Village of Bayside
9075 N. Regent Rd.
Architectural Review Committee Meeting
June 3, 2019
Village Board Room, 6:00pm

**ARCHITECTURAL REVIEW COMMITTEE
AGENDA**

SITE SURVEY FOR:
 MARK A. and ANNE BERKOFF
 SITE ADDRESS:
 9240 N. TENNYSON DR.
 BAYSIDE, WISCONSIN 53217

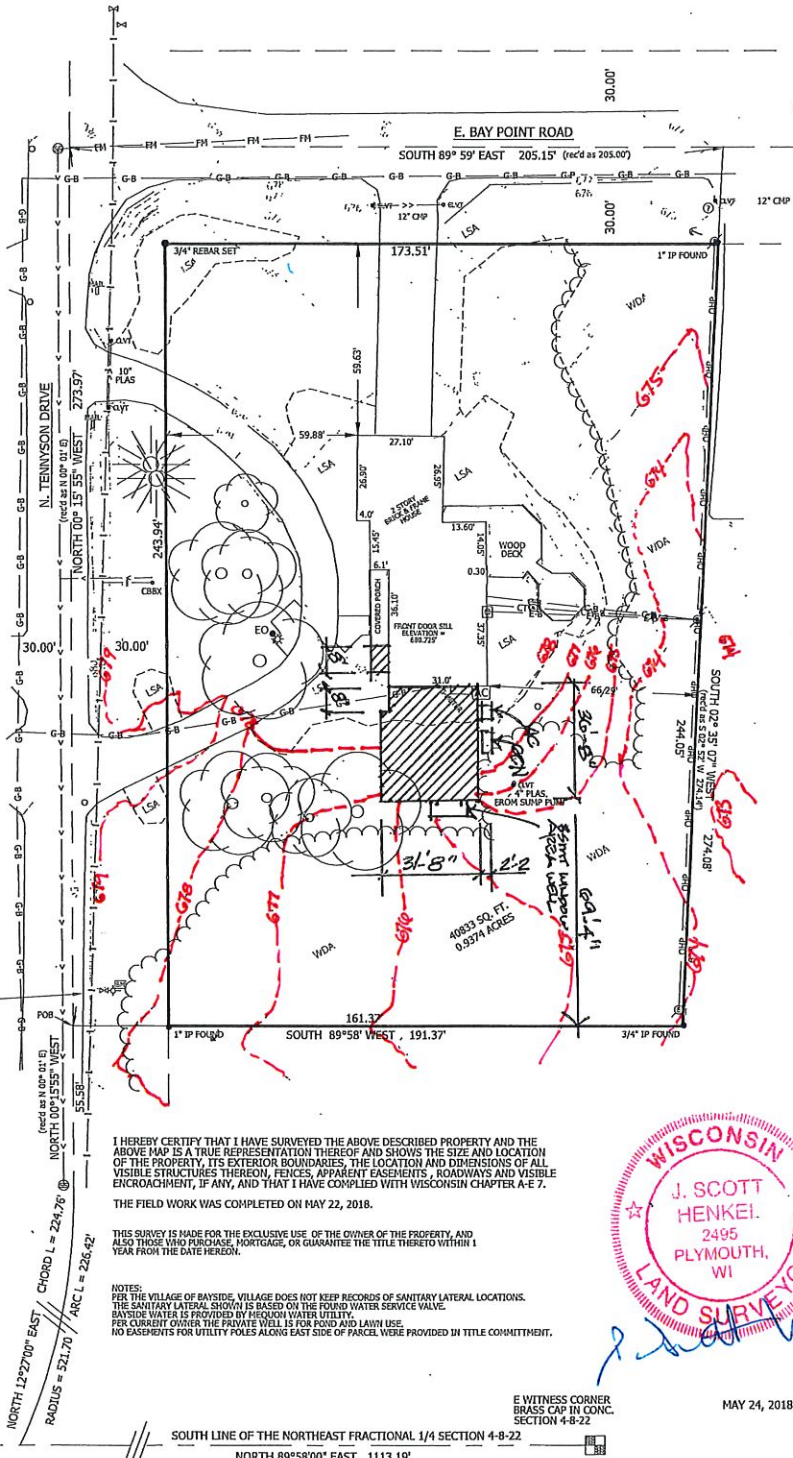
Proposed addition complies with setbacks and maximum site coverage as allowed by Village code.

This review is for ARC only. UDC review required to verify size of new basement bedroom egress window, safety glazing at bathtub and on stairs, etc.

BAYSIDE OPEN PANTRY
OPEN PANTRY FOOD MARTS
 501 BROWN DEER ROAD
 BAYSIDE, WISCONSIN 53217

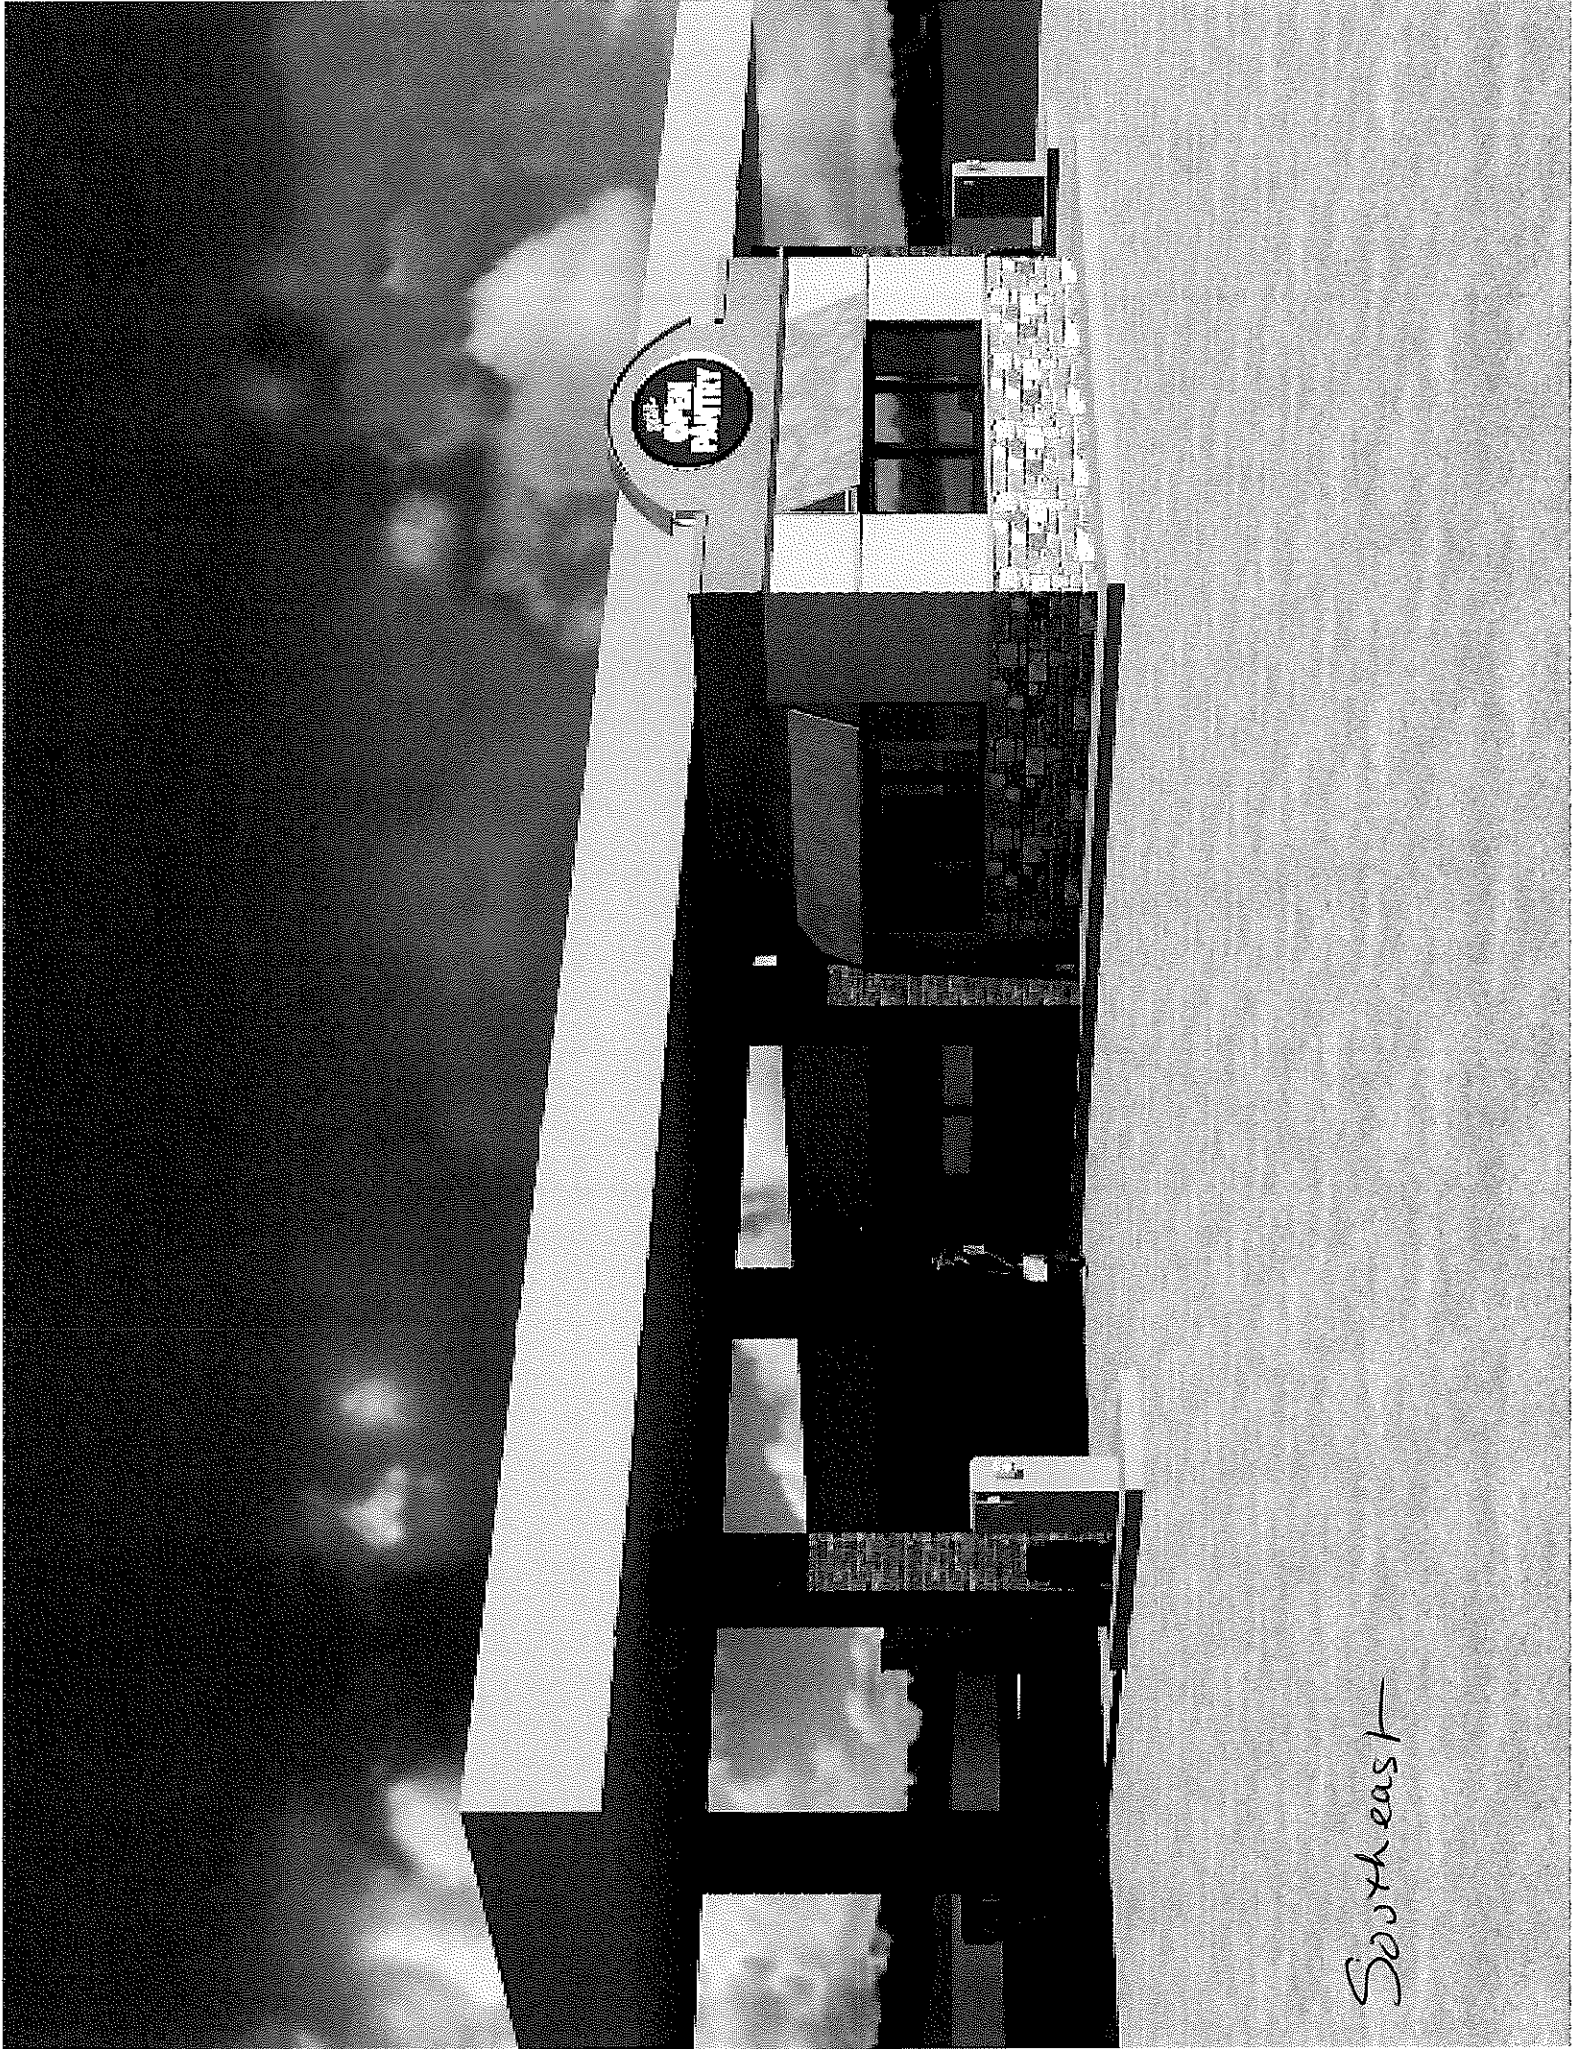
Reviewer believes the exterior improvements proposed for this project significantly improve the existing appearance of the commercial building and provide a more pleasing exterior aesthetic. Reviewer believes this project complies with the following Village Code sections:

Architectural Review Committee shall make final determination of approval of the proposed roof design relative to existing nearby structures.
